On Tuesday, Dec. 4 from 4:00 - 8:00pm at the Renaissance Asheville Hotel (31 Woodfin St 28801), North Carolina Department of Transportation hosts public comment on the I-26 Connect project.

Asheville on Bikes has reviewed NCDOT's I-26 Connector plan and has compiled a list of recommendations to advance bicycle and pedestrian facilities. AoB recognizes that this project will have major negative impacts on our community but we acknowledge that the project is inevitable and, therefore, seek to maximize active transportation facilities and connectivity.

Specific Design Comments (all referenced by letter in the map excerpts):

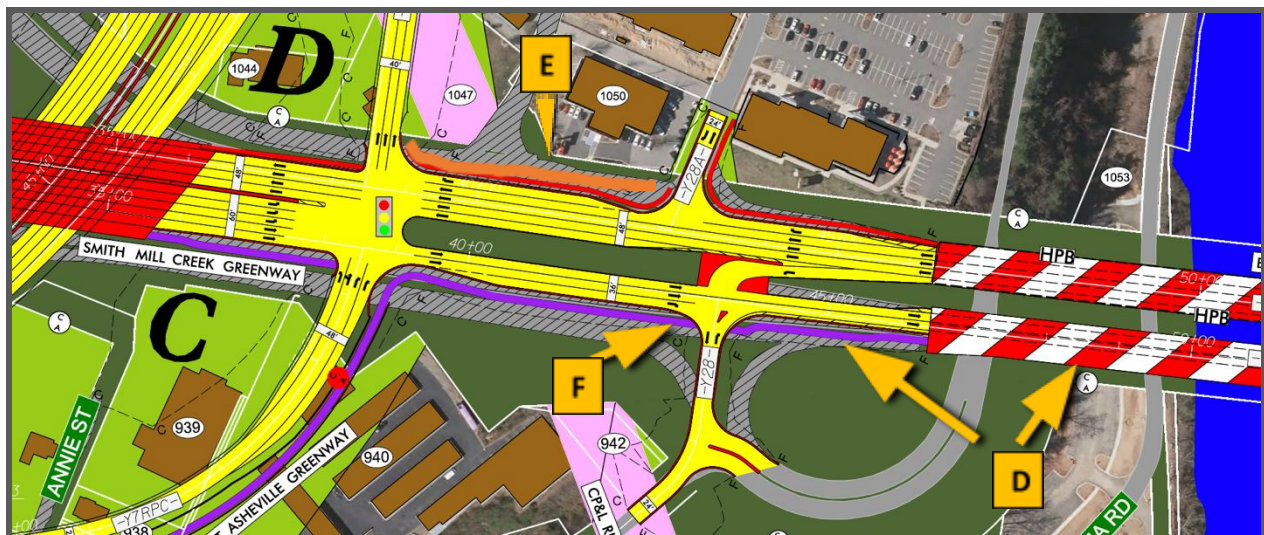
The current caged walkway connecting the Hillcrest neighborhood across Patton Avenue is not suitable for future use, especially given the presence of the new greenway. It is narrow, caged, with steep steps, and not functional for bicycle use. A new structure should be included that

features ramps and not steps, is not caged, and is wide enough for bicycle users to pass each other (at least 8'). It should provide a bikeable merge onto the greenway.

Arlington Street should be designed for vehicular traffic @ 25 mph and should include traditional bicycle lanes of 5' on each side of the travel lanes. This will be a heavily-used bicycle connector for the Hillcrest neighborhood and for all of the Montford neighborhoods via Hill St. and Courtland St.

A neighborhood connector path (8' wide, simple asphalt) should be provided, connecting the greenway to Club St. This will ensure that cyclists and pedestrians are not forced to travel all the way to Clingman Ave. to access the Chicken Hill neighborhood and the River Arts District. Many bike/ped users of the greenway travelling across the Bowen Bridges from the west will have the River Arts District as their destination.

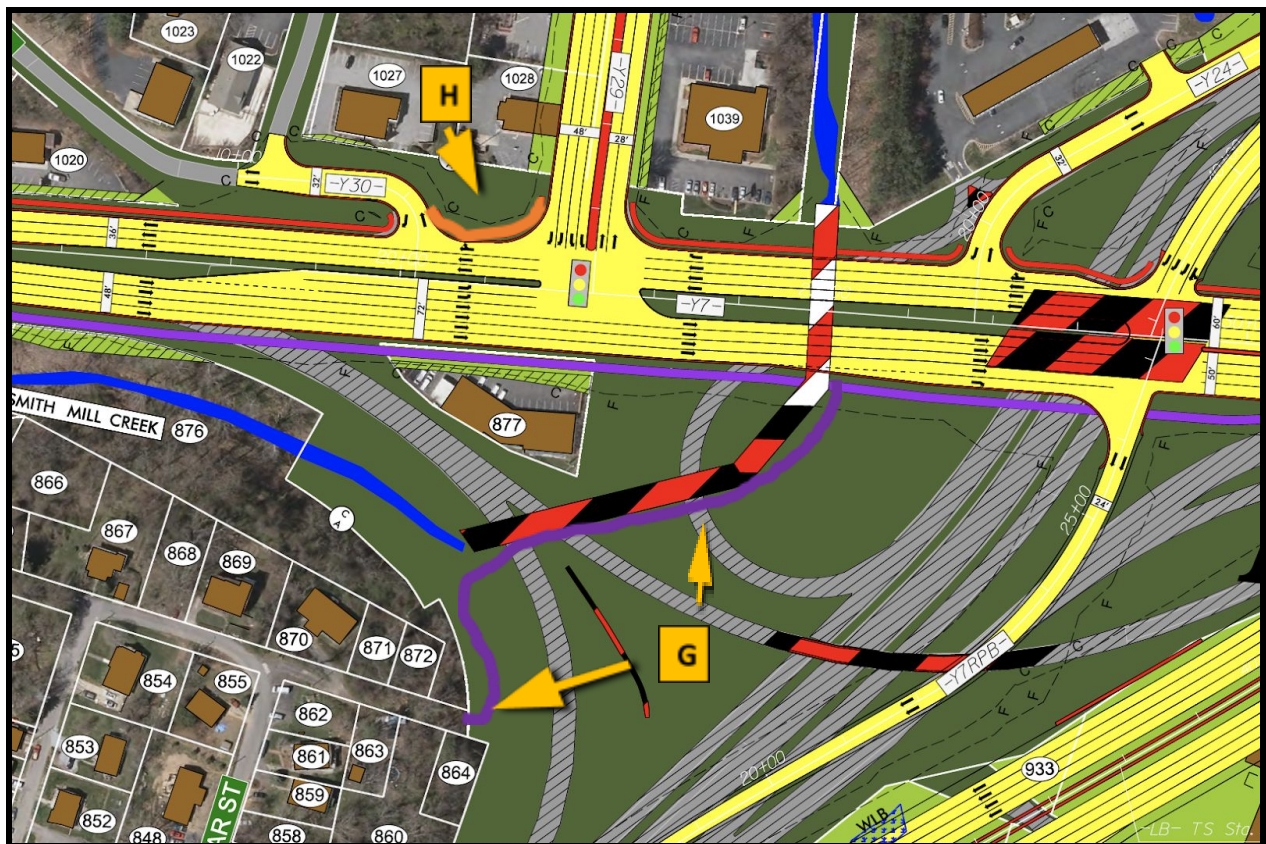
The portion of the West Asheville Greenway that runs from its merge with Smith Mill Creek Greenway to Clingman Avenue, given number of people living along each greenway and their desire to travel to and from downtown, or to enjoy the view overlooking the river, could well be the most heavily used section of greenway anywhere in the community and perhaps in the state of North Carolina. AASHTO standards provide guidance for greenway width specifications based on use levels, and accordingly this section of greenway should be designed at 16' wide. All greenways and MUPs throughout the project should include standardized pavement markings to assure safety and minimize user conflicts.

If we assume that a multi-use facility is built on the north side of the Wally Bowen bridge, then this facility will be subject to heavy usage from cyclists and pedestrians accessing Westgate Shopping Center. Instead of a 6'-wide standard sidewalk in this location, there should be a 10'-wide marked MUP to accommodate the mix of cyclists and pedestrians.

This will be a very busy intersection for vehicle travel. Because the intersection will not be signalized and will be very active, automobile traffic will typically be moving rapidly between Patton Ave. and Hazel Mill Rd. The greenway will be very busy here, and potential for safety problems will be very high, especially in the evenings and other times of low visibility. Signalized bicycle and pedestrian crossings, traffic calming, and other measures should be deployed to ensure safe crossing of Hazel Mill Rd. for greenway users. Additionally, Hazel Mill Rd. as it leaves Patton will be a very popular route for bicycles and pedestrians to access the River Arts District on the west side of the river. The section of Hazel Mill to be rebuilt here by DOT should incorporate sidewalk and bicycle design features.

A neighborhood connector MUP (8' wide, simple asphalt) should be provided to connect the Burton Street neighborhood to the Smith Mill Creek Greenway. Otherwise, cyclists and

pedestrians in those neighborhoods could be forced to travel much greater distances uphill and westward for access.

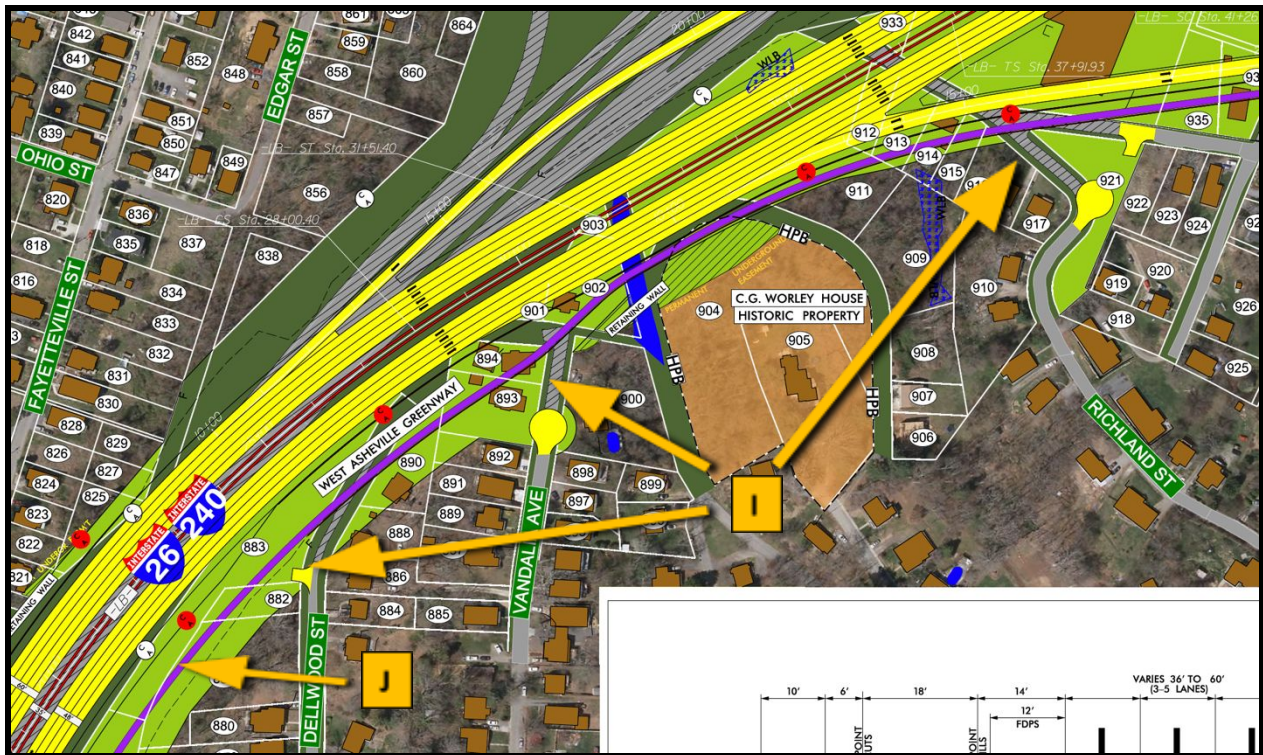
Residential areas branching from the Hazel Mill Rd. corridor are very populous and growing. Hazel Mill Rd. will be a busy and popular route for those seeking access to Smith Mill Creek Greenway and points beyond. The Hazel Mill / Patton intersection here should be connected to the Regent Park/Patton intersection by a 10' wide properly marked MUP to provide adequate safe connection. A simple 6' sidewalk here is not suitable for cyclists and pedestrians to mix, especially at the edge of Patton Ave.

Neighborhood MUP connectors (8' wide, simple asphalt) should be provided to allow the extensive neighborhoods of East West Asheville to connect to the West Asheville greenway via Dellwood, Vandalia, and Richland Streets. This will significantly reduce the number of cyclists that would otherwise mix in at the Haywood Rd. and Hazel Mill Rd. access sites.

The West Asheville Greenway between Haywood Rd. and the merge with the Smith Mill Creek Greenway is a primary connection between downtown and the River Arts District for a large

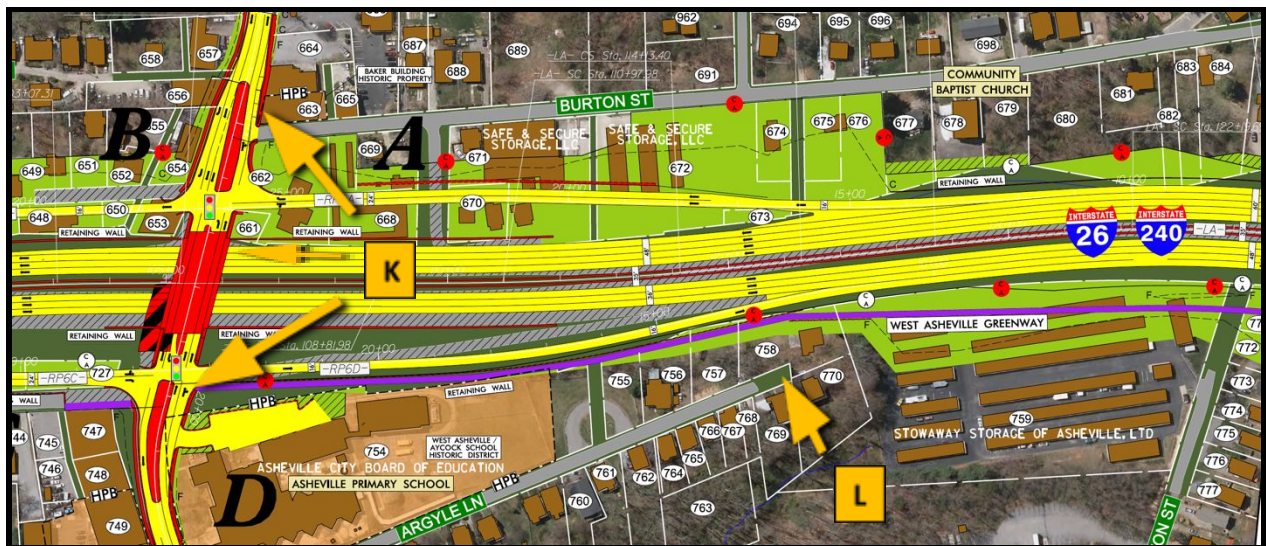
population and will be very busy. Accordingly, per AASHTO guidance, it should be sufficiently wide (14') and properly marked.

The Haywood Rd. bridge over I-26 and the intersection with the West Asheville Greenway will be a very busy area for cyclists given the populous neighborhoods and popular commercial areas that radiate from here and public school adjacent to the intersection. As currently depicted, the bridge and the approaches do not incorporate bicycle features or safe pedestrian facilities. The current design allows for increased automobile speeds compared to the immediately adjoining sections of Haywood Rd. Traffic calming features, narrower travel lanes, and traditional 5' bike lanes should be incorporated on Haywood, as should NACTO-standard intersection treatments.

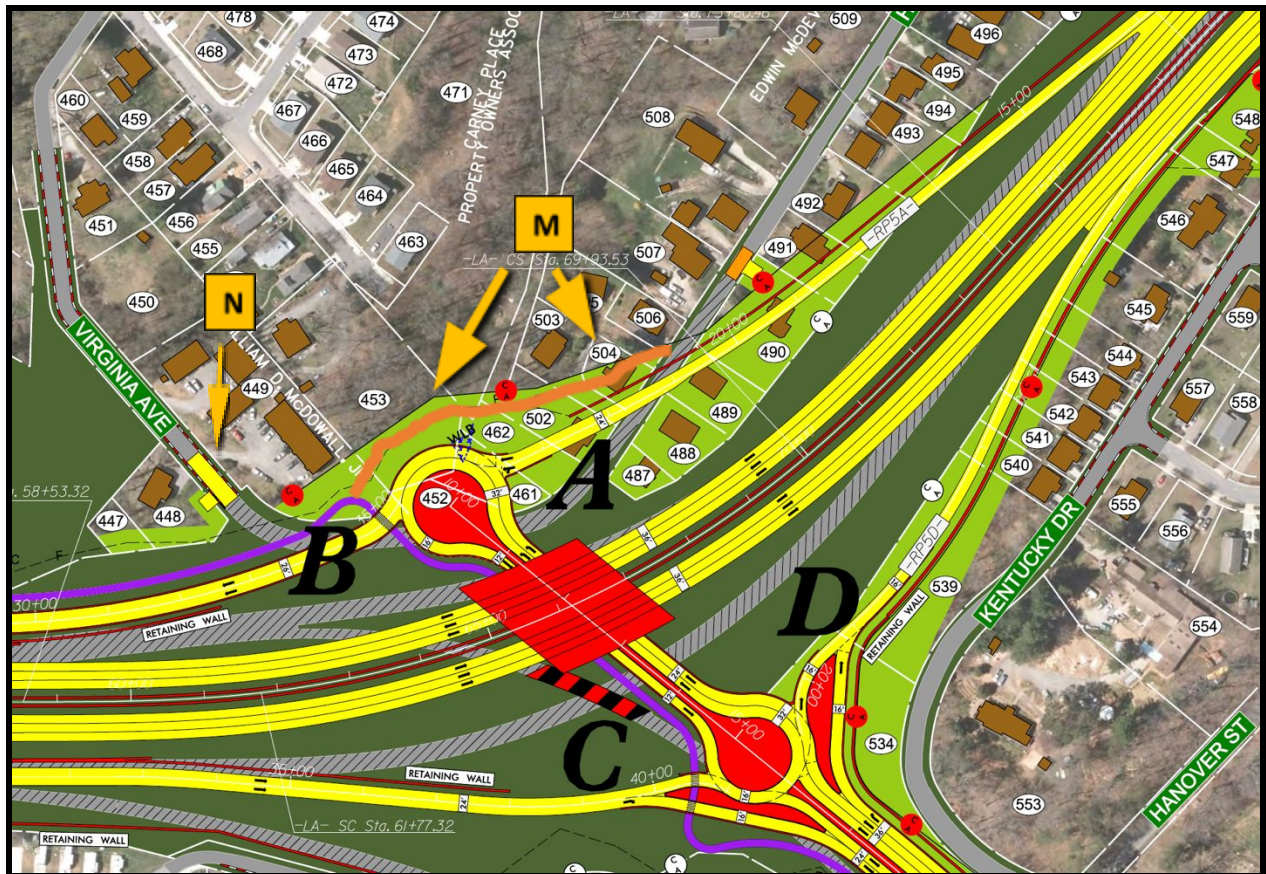
A neighborhood connector MUP (8' wide, simple asphalt) should be provided to connect Argyle Ln. to the West Asheville Greenway.

In the proposed design, Hubbard Avenue in West Asheville would be significantly isolated and unconnected to Virginia Ave. and other possible connections to the Amboy Rd. MUP due largely to topography. An additional section of neighborhood connector MUP (8' wide, simple asphalt) should be included. This will allow for neighborhoods beyond Hubbard to also connect efficiently to Hominy Creek, Carrier Park, and other areas.

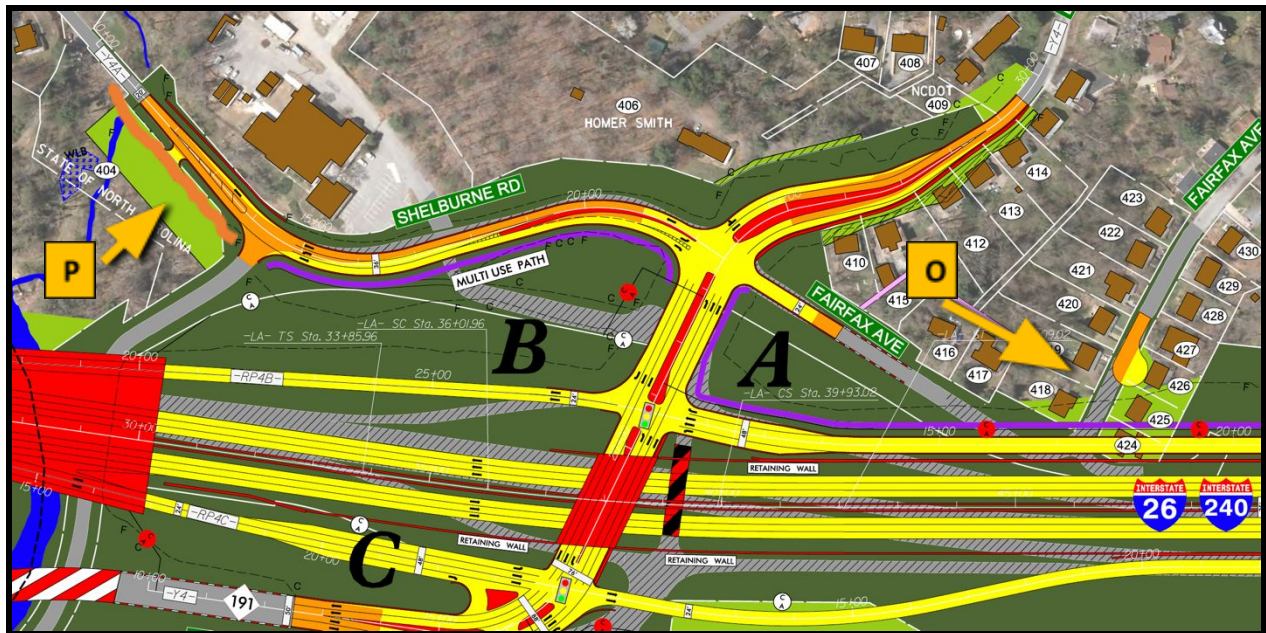
There should be a neighborhood connector MUP (8' wide, simple asphalt) from Virginia Ave. to the Amboy Rd. MUP.

There should be a neighborhood connector MUP (8' wide, simple asphalt) connecting Fairfax Ave. to the Amboy Rd. MUP

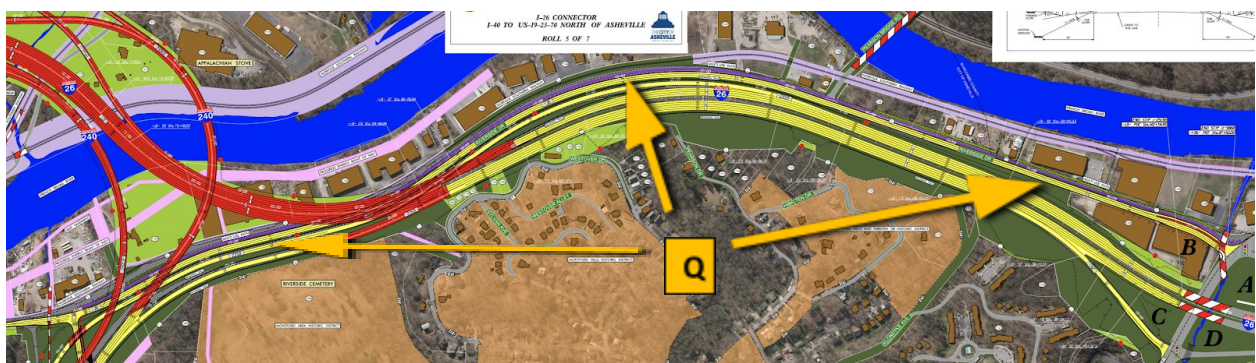
A section of standard MUP (10' wide, marked), should be provided to extend the Amboy Rd. MUP to the trailhead of the City's current Hominy Creek Greenway. Without this connection, cyclists and pedestrians would be forced out into this busy part of Shelburne Rd. due to the steep bank that exists there now between the roadways and the DOT-owned paved parking area.
